JAFP-12-0032
March 30, 2012

SUBJECT: Response to Request for Additional Information Re: Application for Change to the Current Licensing Basis, Authorizing use of On Load Tap Changers with the Reserve Station Service Transformers (TAC No. ME6887)
James A. FitzPatrick Nuclear Power Plant
Docket No. 50-333
License No. DPR-59

Responses to Request for Additional Information Questions

Figure 1 Typical Pre Transfer Voltage Control and Limit Bands

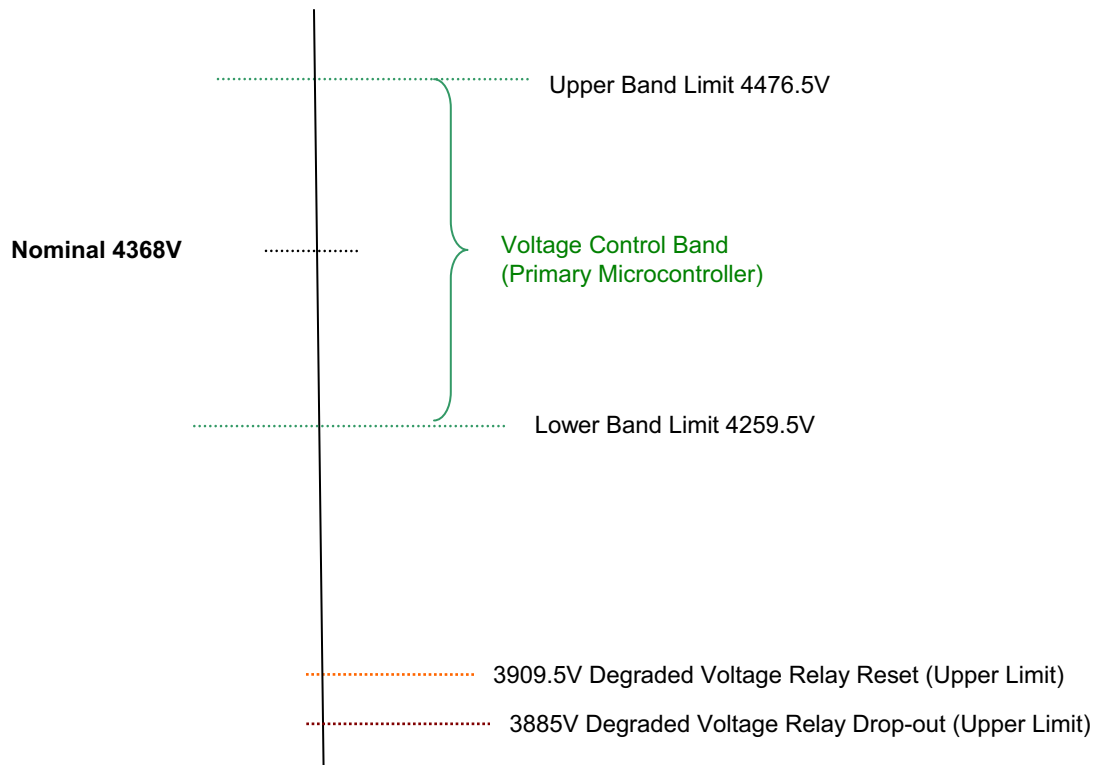
In the LAR, Attachment 1, Page No. 9, the following is stated: "The 4400V used in Figure 1 is 110% of the voltage rating of the safety-related motors fed from the bus, consistent with ANSI/NEMA Standard MG-1-2009, Revision 1-2010, "Motors and Generators."

The staff finds that in Figure 1, the nominal voltage shown in Figure 1 is 4441.5V instead of 4400V. Please provide an explanation for this discrepancy.

The Reserve Station Service Transformers are normally in the energized unloaded condition. In this configuration the electrical buses and loads are not fed from the Reserve Station Service Transformers; however, the transformers and electrical non-segregated phase buses are energized and controlled between 4259.5V and 4476.5V (see revised Figure 1 and 2 below), with the microcontroller OLTC Pre Transfer nominal setting of 4368V. The Reserve Station Service Transformers are rated for 4,800V and the electrical non-segregated phase bus is rated for 5,000V; as such the electrical equipment is designed for the applied voltage.

- JAF-11-0102 Attachment 1 page 4 of 20, replace “Figure 1 Typical Pre Transfer Voltage Control and Limit Bands” with the following:

JAMES A. FITZPATRICK		FSAR UPDATE	
PLANT ELECTRICAL DIAGRAM			
REV. 3	MAY 1997	FIGURE NO 8-2-1

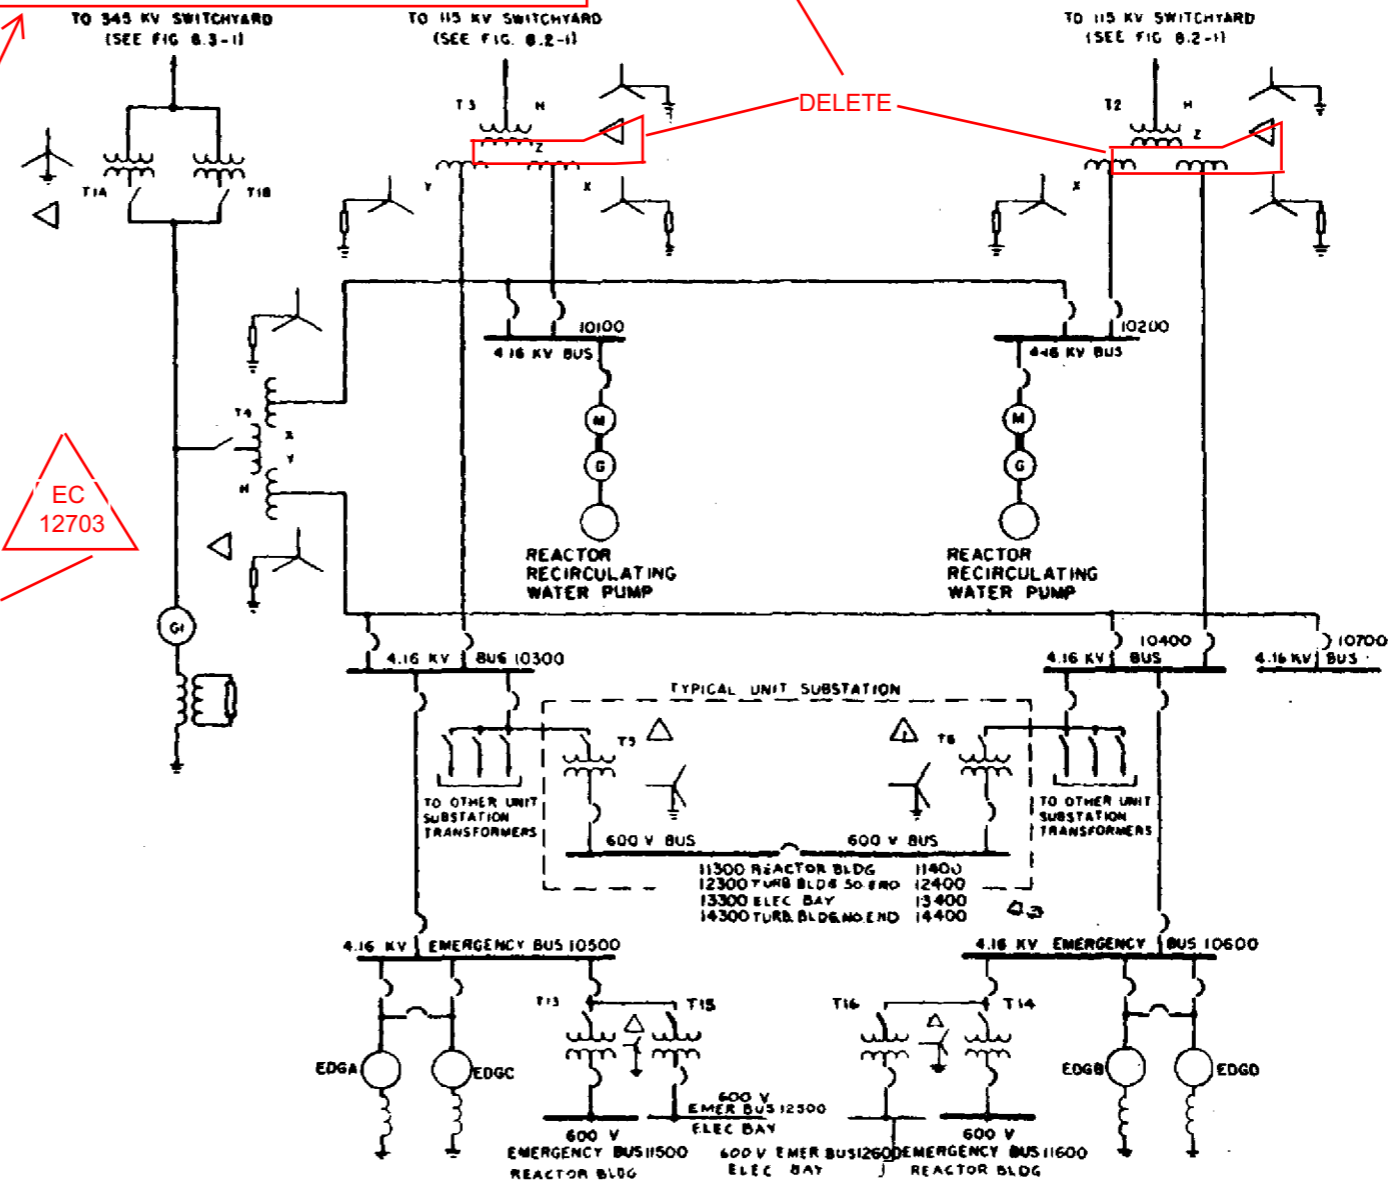
“Provide revised Figures 8.2-1 and 8.5-1 of Updated Final Safety Analysis Report and any others, in which the new ratings of RSSTs are shown.”

Draft copies of Updated Final Safety Analysis Report Figures 8.2-1, 8.3-4, 8.5-1, 8.5-3 and 8.5-4 are provided in Enclosure 2. Drafts are provided since the figures can not be finalized until the new Reserve Station Service Transformers (RSST's) are installed. Included in Enclosure 3 are copies of the UFSAR changes related to the existing Reserve Station Service Transformers (RSST's) that are currently being processed as a result of a revision to an electrical calculation. This change affects Figure 8.6-1, section 8.6.6 and Table 8.6-1.

T2 & T3 - 15/20/25 MVA (65 C), 115-4.16-4.16 KV, 3 PH,
 60 CY, ONAN/ONAF1/ONAF2, 65 C Rise
 H Winding - 15/20/25 MVA
 X Winding - 5/6.66/8.33 MVA
 Y Winding - 10/13.33/16.66 MVA

4160V ONE LINE DIAGRAM
SH. 2 BUS 10300

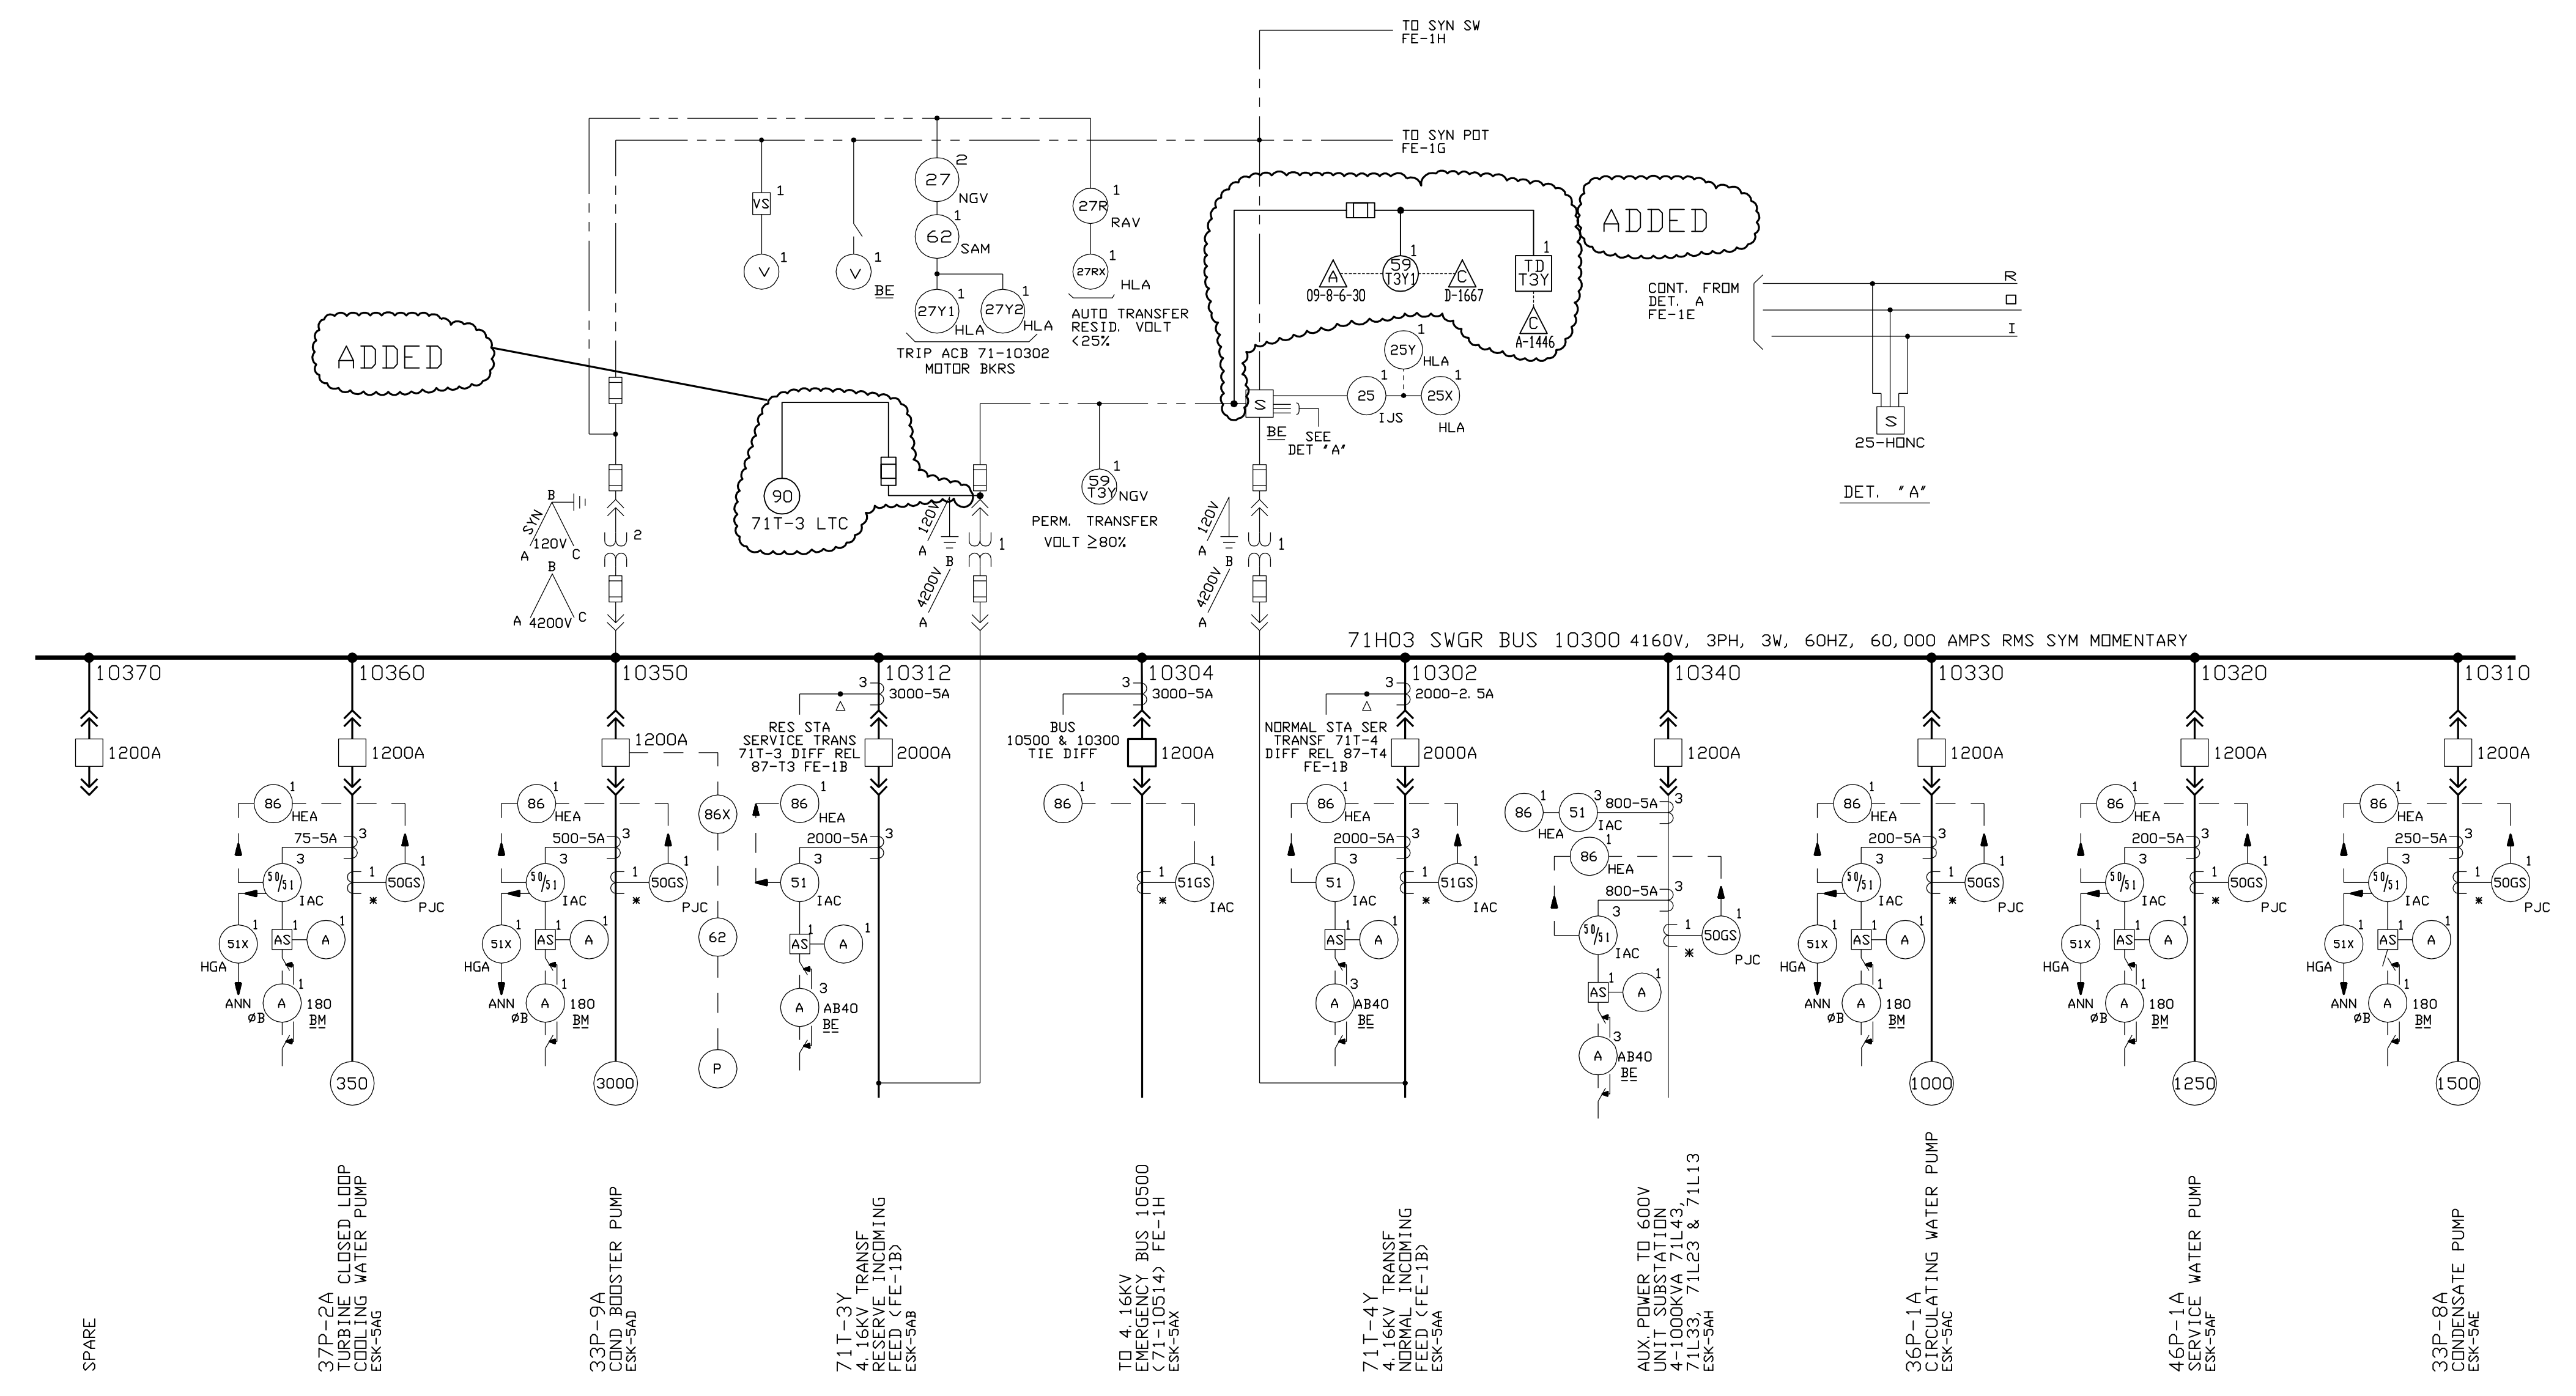
Provide a copy of the diagram which shows the connection of the potential transformer that is located between the RSST secondary windings and the 4kV RSST bus supply breakers. Also, identify which 4kV buses are monitored and controlled by the OLTC, and which 4kV buses are shown in Figures 1 and 2 of the LAR.”

Modification drawing FE-1F (Enclosure 4) shows the connection of the potential transformer that is located between Reserve Station Service Transformer 71T-3 low voltage “Y” winding and non-safety related bus 10300 (71H03). Modification drawing FE-1G (Enclosure 4) shows the connection of the potential transformer that is located between Reserve Station Service Transformer 71T-2 low voltage “Y” winding and non-safety related bus 10400 (71H04). (Note: The JAF RSST's are normally energized and unloaded.) The OLTC's monitor and control voltage to 4.16kV switchgear buses 10300 (71H03) and 10400 (71H04) that supply power to downstream safety related buses 10500 (71H05) and 10600 (71H06). Also included in Enclosure 4, are modification drawings FE-1B, which provides an electrical one line diagram of Station Service Transformers, and 1.22-106 which details the Reserve Station Service Transformer connections to the OLTC. The “Typical Pre Transfer Voltage Control and Limit Bands” shown in Figure 1 of the LAR and the “Typical Post Transfer Control and Limit Bands” shown in Figure 2 of the LAR are applicable to the 10300 (71H03) and 10400 (71H04) buses.

**Replacement RSST's Non-Safety Related / ECCS
Load Sequencing Voltage Profile
(1 Page)**

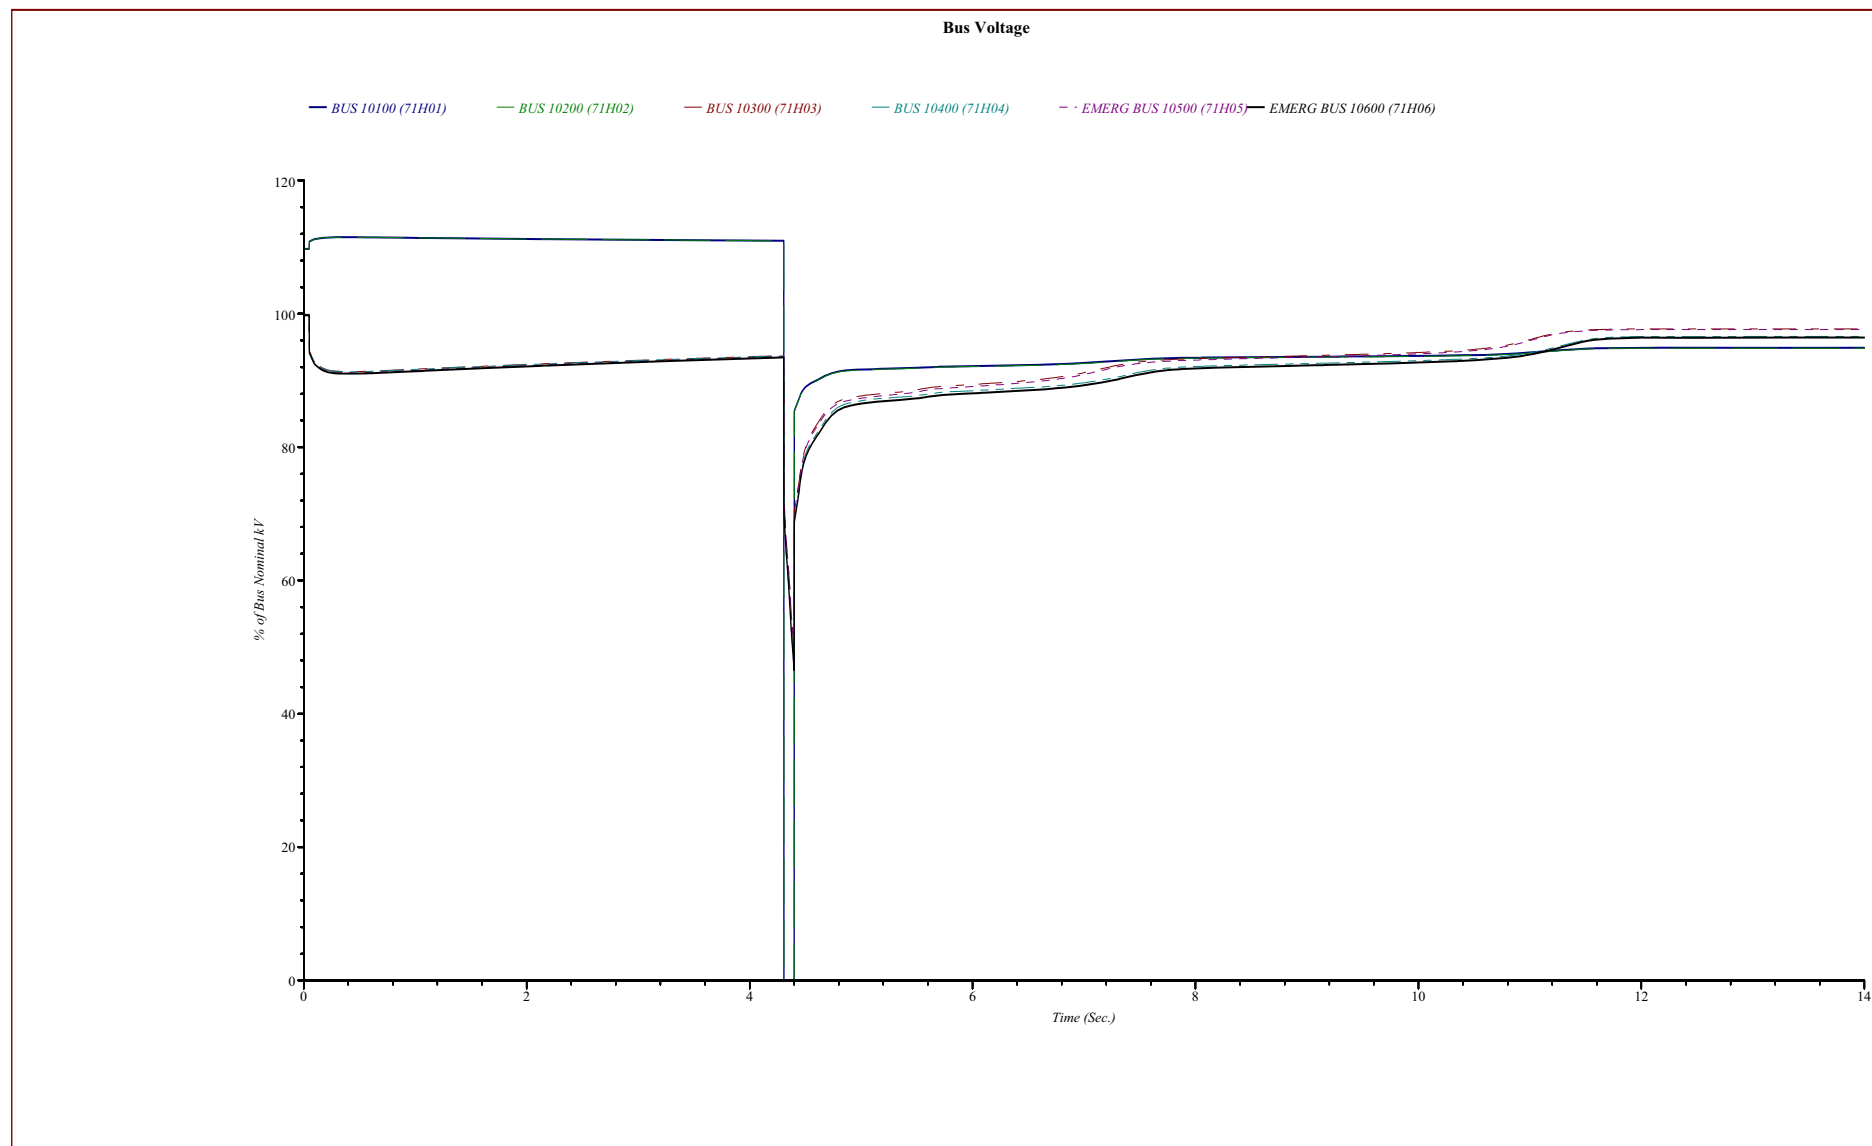
"In order to find the voltage improvements due to the OLTC, please provide the voltage profiles for the 4kV major load buses in the following scenarios:

- a. Accident load sequencing with the 115kV switchyard voltage at the minimum voltage level, without OLTC (prior to proposed amendment).
- b. Same as (a) but with new RSST and OLTC in normal operation.
- c. Non-Accident load sequencing due to spurious sudden trip of the main generator, with the 115kV switchyard voltage at the minimum voltage level, loads fast transfer to RSST (prior to proposed amendment).
- d. Same as (c) but with new RSST and OLTC in normal operation."

- b. The transient voltage profile of the 4kV buses resulting from a transfer of non-safety related loads from the Normal Station Service Transformer to the replacement Reserve Station Service Transformer and the sequencing of ECCS loads with the OLTC is in an automatic mode of operation. It is provided on the attached Transient Stability Analysis plot labeled "JAF-CALC-11-00002 Attachment 6 Page 103" in Enclosure 5.
